Access Compliance Report

Public Rights-of-Way

(Curb Ramps)

Intersection ID: 7867	Main Street: BROOKTREE_DR	Cross Street: TODDVILLE_RD	Location: SE
ADA ID: EDA70D98C65D	Ramp Type: Perp	Initial Pass/Fail: Fail	Overall Compliance: No
Severity Score: 10			
Codes/Mitigation Info/Possible Solution		Field Measurements/Component Compliance

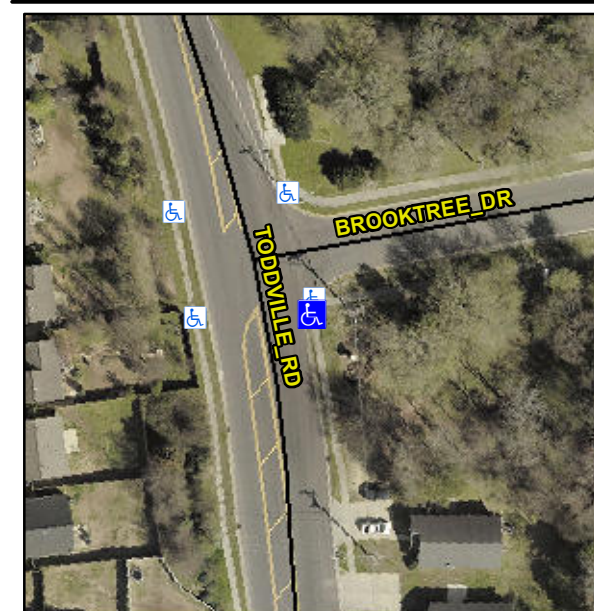
Not Found, R304.5.1

Compliance	Description	Data	Compliance	Description	Data
N/A	Ramp Length (in)	48.0	Yes	Ramp Slope (%)	5.0
No	Ramp Width (in)	47.0	Yes	Ramp XSlope (%)	4.1
N/A	Flare Type LT	N/A	N/A	Flare Type RT	N/A
N/A	Flare Slope LT (%)	N/A	N/A	Flare Slope RT (%)	N/A
N/A	Flare Traversable LT?	N/A	N/A	Flare Traversable RT?	N/A
N/A	Landing Length (in)	N/A	N/A	DWS Provided?	N/A
N/A	Landing Width (in)	N/A	N/A	DWS Contrast?	N/A
N/A	Landing Slope (%)	N/A	N/A	DWS Length (in)	N/A
N/A	Landing X Slope (%)	N/A	N/A	DWS Full Width?	N/A
N/A	Landing Curb? (Y/N)	N/A	N/A	DWS Offset (in)	N/A
N/A	Shared Landing?	N/A			
N/A	Gutter Ponding?	N/A	N/A	Gutter Slope (%)	N/A
N/A	Gutter Lip Ht (in)	N/A	N/A	Gutter X Slope (%)	N/A
N/A	Painted X Walk1?	No	N/A	Painted X Walk2?	N/A
	X Walk 1 Direction	To W		X Walk 2 Direction	N/A
N/A	X Walk 1 Width (in)	N/A	N/A	X Walk 2 Width (in)	N/A
	X Walk 1 Slope (%)	6.8		X Walk 2 Slope (%)	N/A
	X Walk 1 X Slope (%)	6.2		X Walk 2 X Slope (%)	N/A

Remove & Replace Entire Ramp.
